Attachment 3

Revision FSAR Chapter 2, Subsection 2.5.4

1. COLA Part 2, FSAR Chapter 2, Subsection 2.5.4, third paragraph is revised as follows:

FIGURE 2.5.4-202

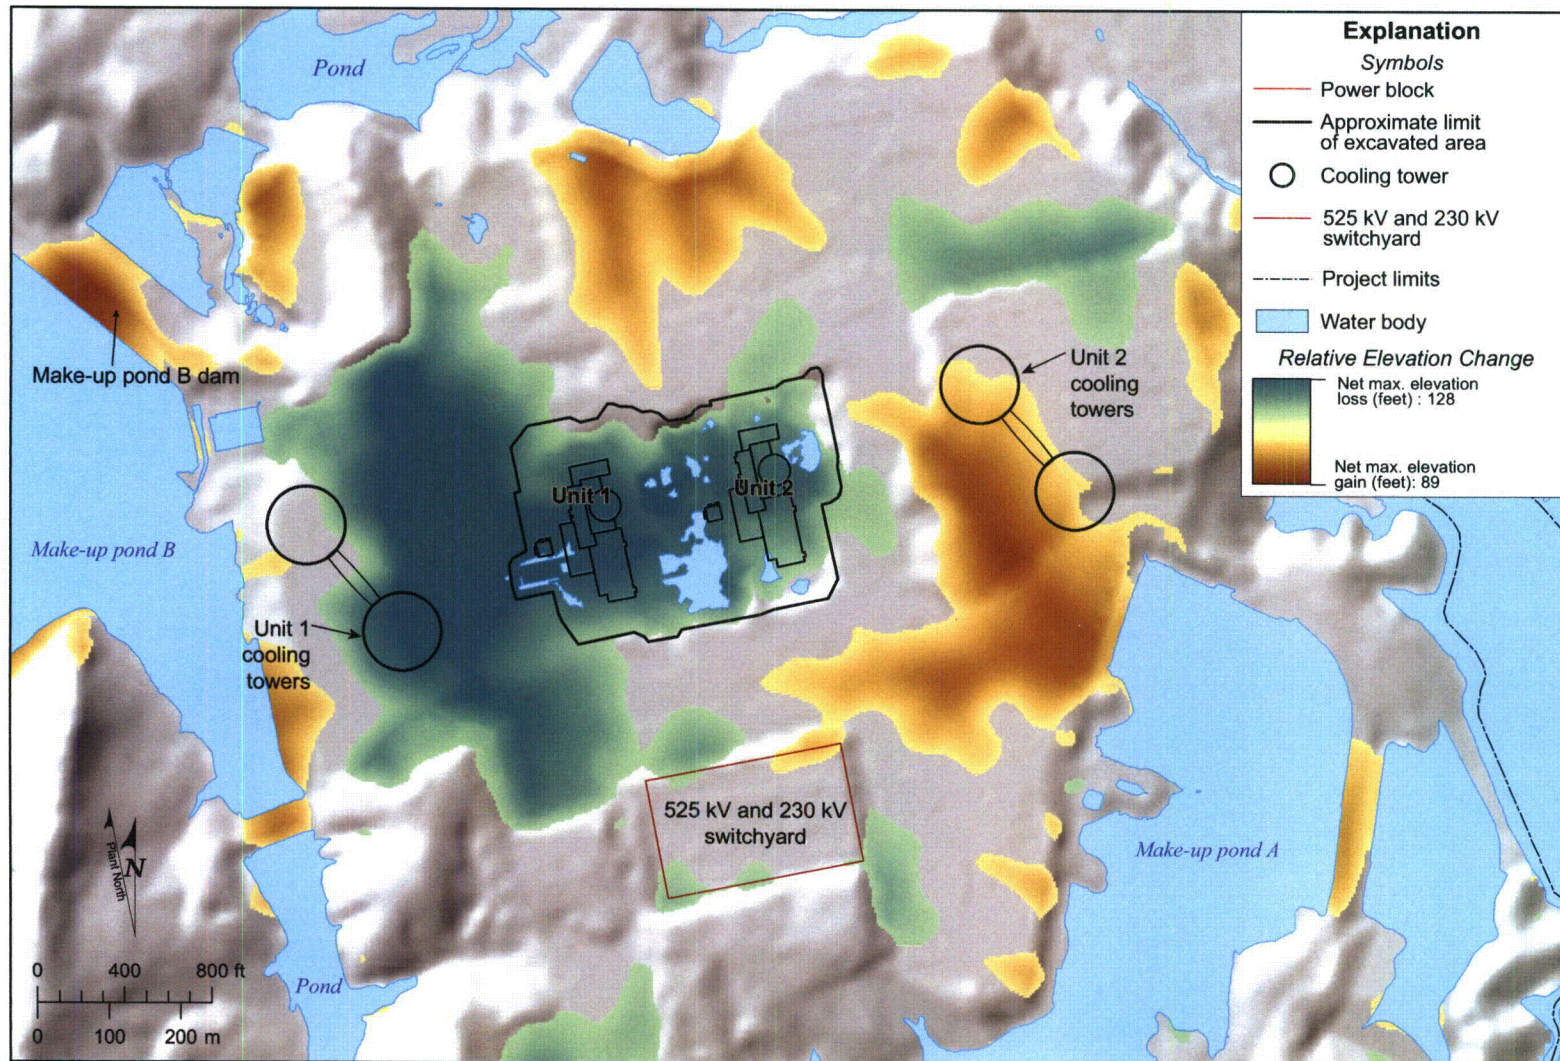
73. COLA Part 2, FSAR Chapter 2, Figure 2.5.4-202 is revised as follows:

FIGURE 2.5.4-208

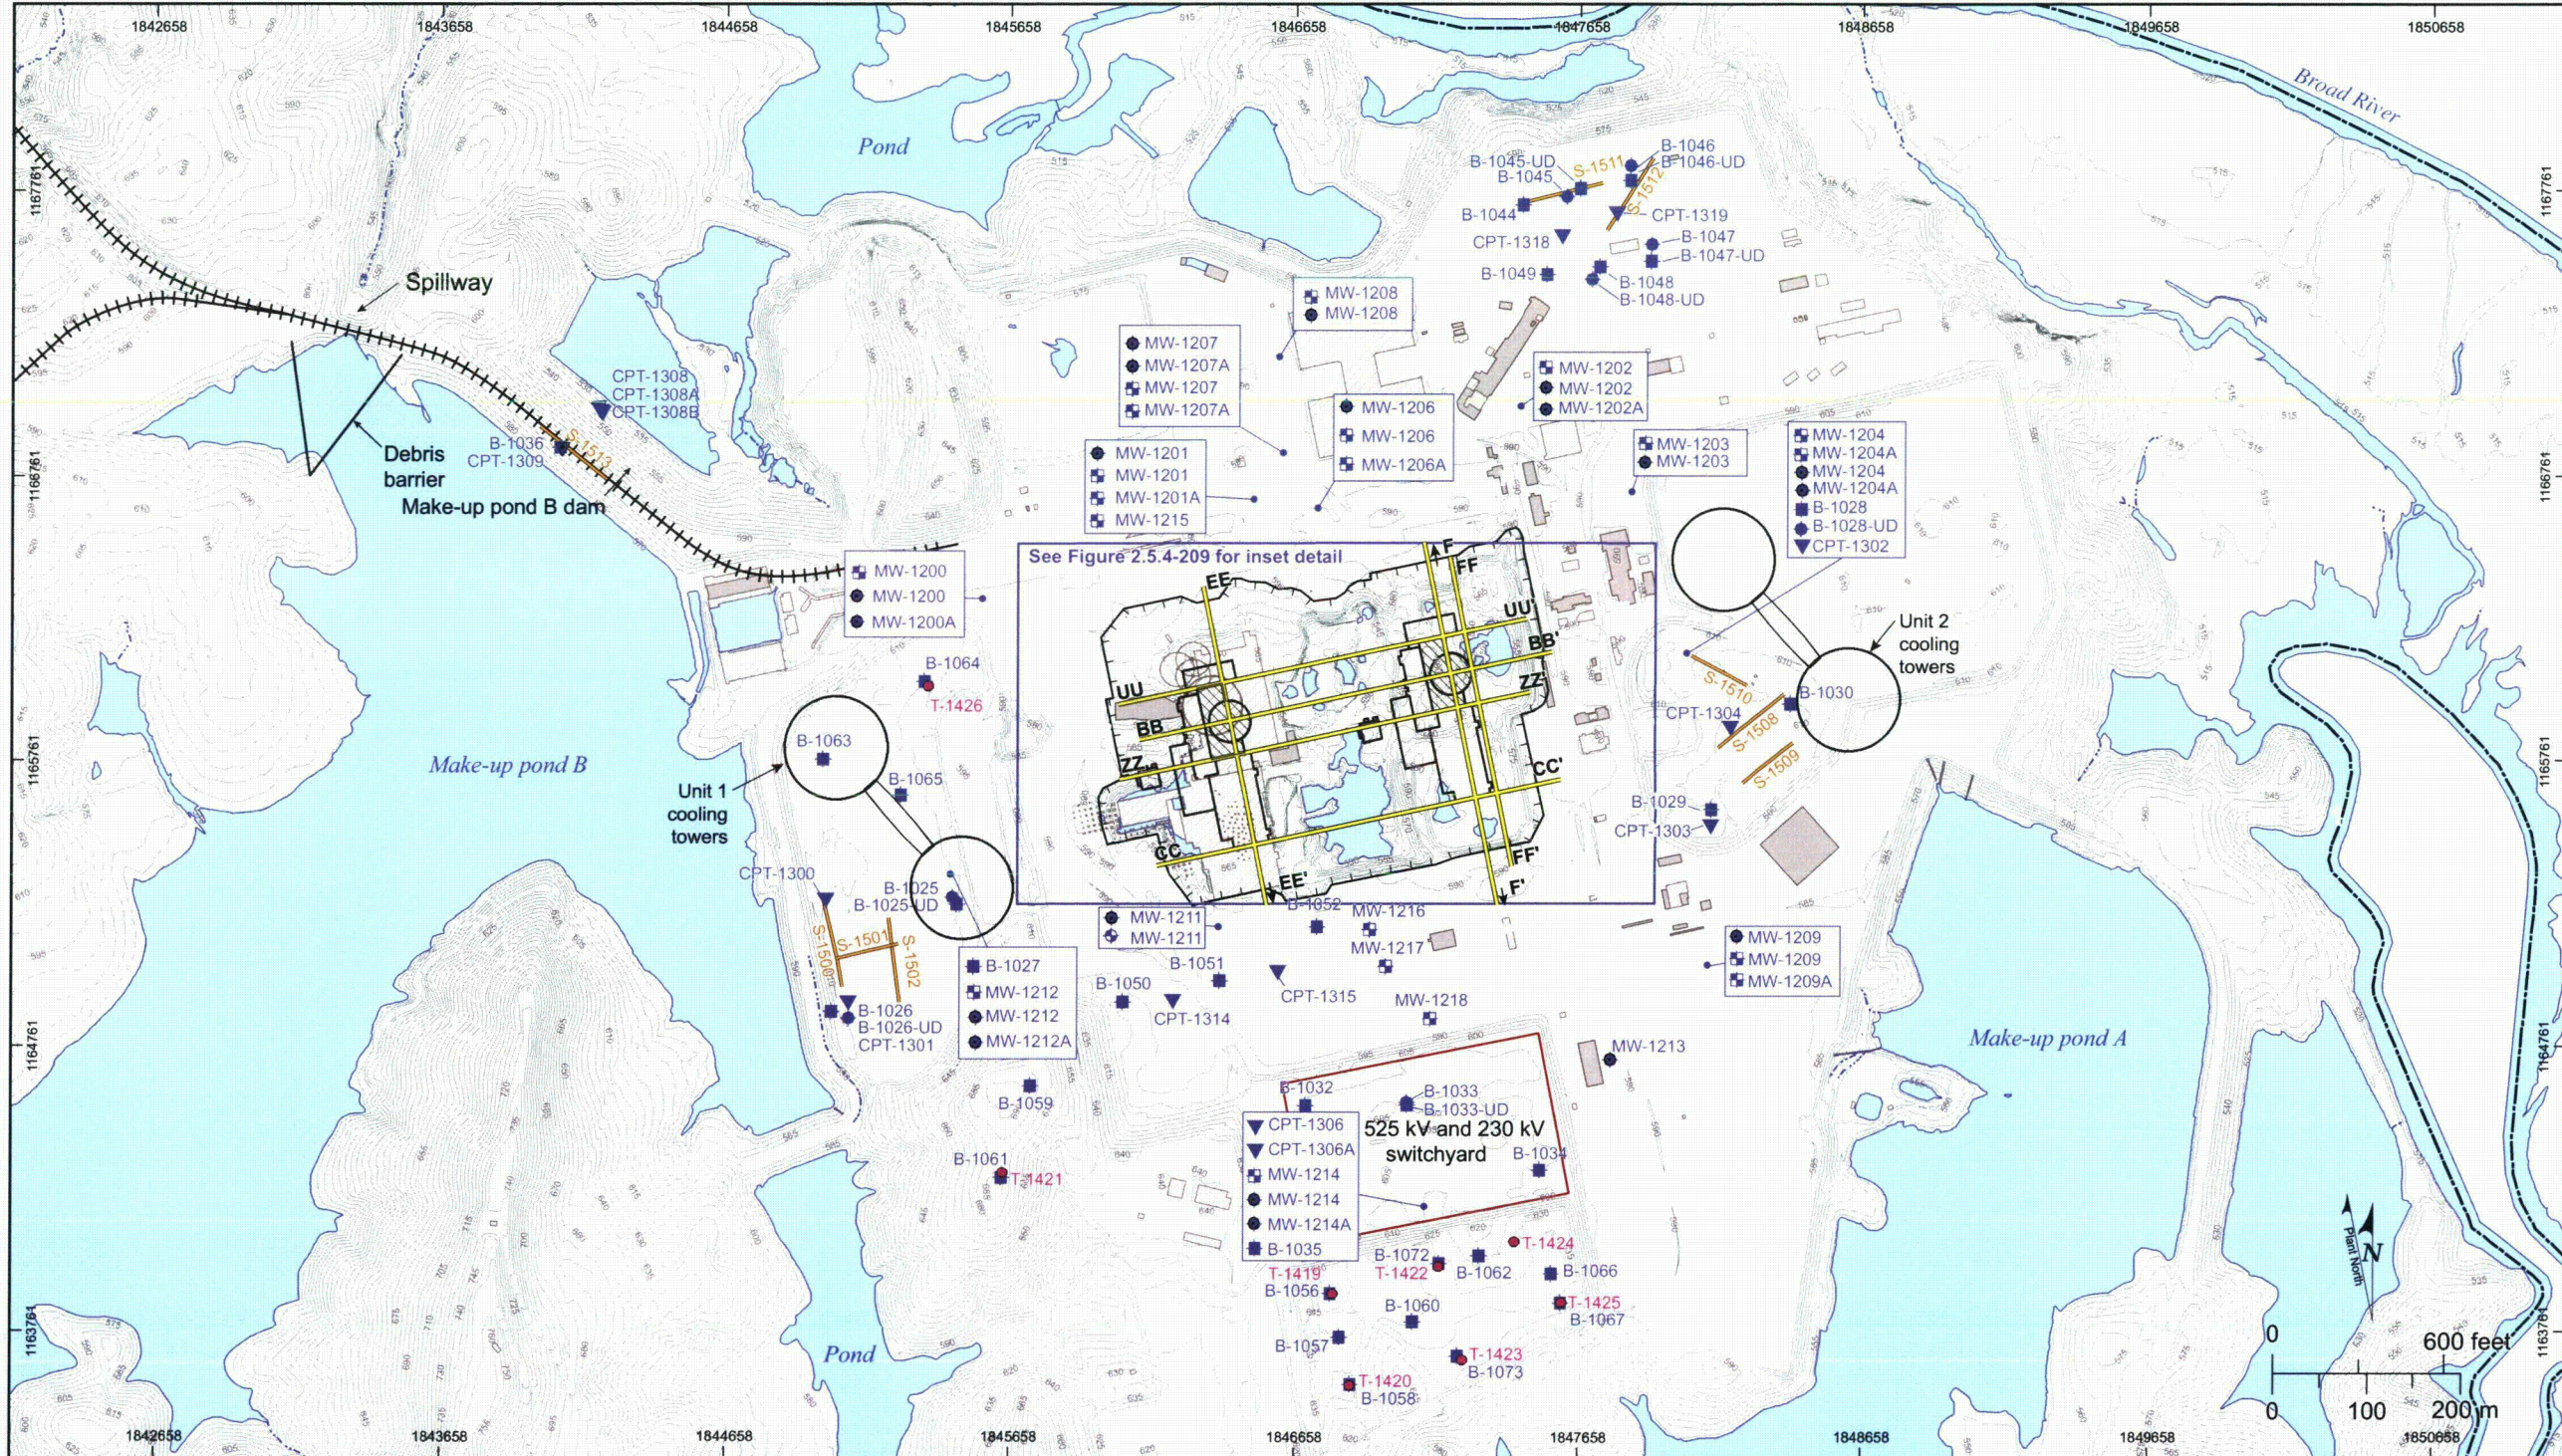
A comprehensive exploration program of surface geophysics, in situ testing, and subsurface drilling and sampling was conducted in 2006-2007 as shown in a site view on Figure 2.5.4-208 and Power Block and Adjacent Areas on Figure 2.5.4-209. These figures show the principal and secondary exploration borings and other field explorations performed. The historic boring locations on this figure are identified to distinguish them from the 2006-2007 boring and test locations. The locations of groundwater monitoring wells constructed and packer test performed as part of the Lee Nuclear Station exploration are shown on Figure 2.5.4-210. Figure 2.5.4-211 shows the location of SASW survey lines at the Lee Nuclear Station Site. The location of CPT tests performed as part of the Lee Nuclear Station exploration is shown on Figure 2.5.4-212. The location of test pits and trenches excavated as part of the Lee Nuclear Station exploration is shown on Figure 2.5.4-213. The Goodman Jack and borehole pressuremeter test locations performed as part of the Lee Nuclear Station exploration are shown on Figure 2.5.4-214. The borehole geophysical test locations performed as part of the Lee Nuclear Station 2006-2007 exploration and 2012 exploration are shown on Figure 2.5.4-215. The petrographic test locations performed as part of the Lee Nuclear Station exploration are shown on Figure 2.5.4-216.

The exploration locations made in 2006-2007 are shown on Figure 2.5.4-208. The locations of the borings made in 2012 are shown on Figure 2.5.4-209 in addition to those made in 2006-2007.

As-built survey data and topographic surveys were used to prepare maps of the final geotechnical data exploration program as presented in Figures 2.5.4-208 (2006-2007 explorations only) and 2.5.4-209 (2012 explorations in addition to 2006-2007 explorations). The locations of exploratory borings, monitoring wells, test pits, and surface geophysical lines were recorded in digital format. These data were uploaded into a geographic information system (GIS). The GIS was used to prepare plan view maps and profile drawings that were used to develop geologic interpretations.

FIGURE 2.5.4-218

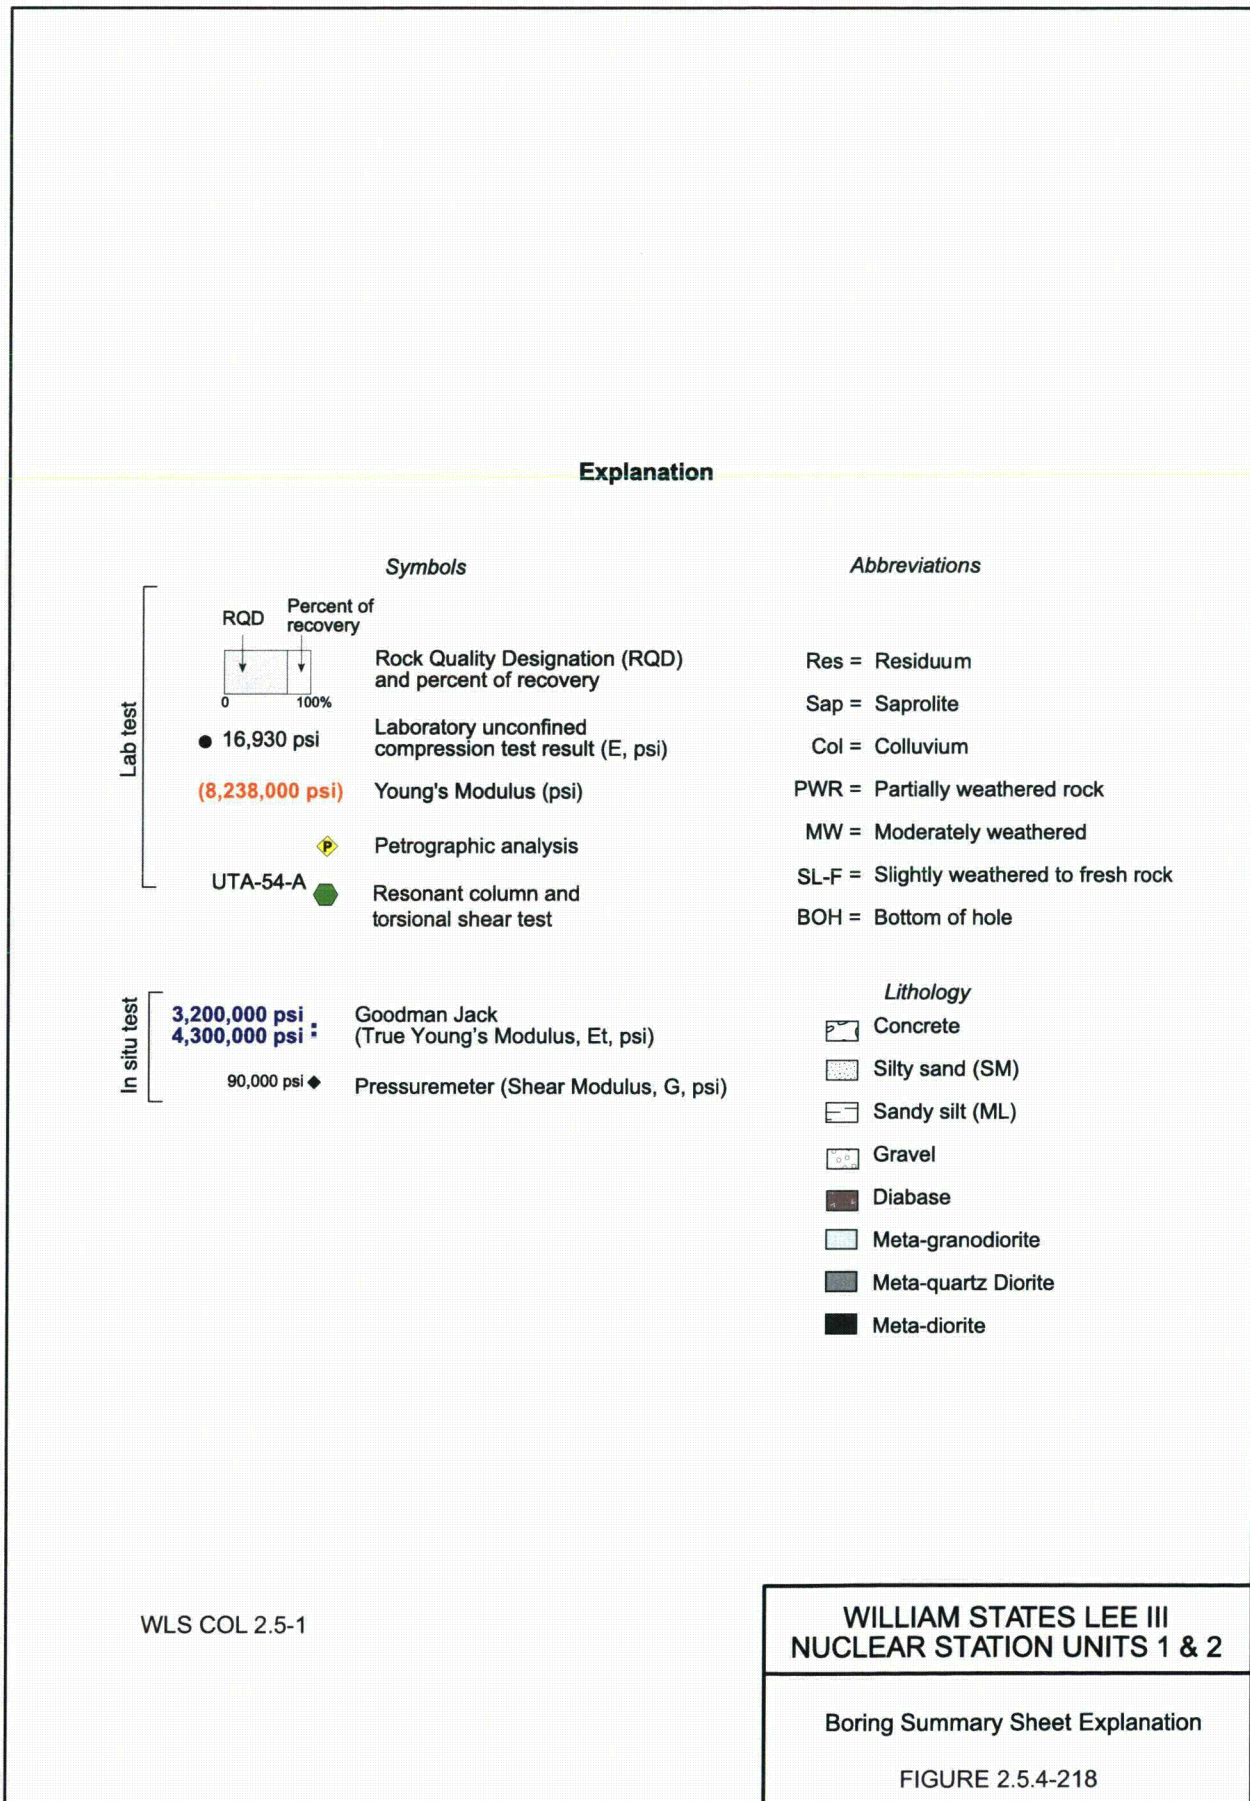
An explanatory figure showing these data sources is included as Figure 2.5.4-218, followed by 214 Borehole Summaries, Figures 2.5.4-219 through 2.5.4-232 and Figures 2.5.4-233a through 2.5.4-232233g.
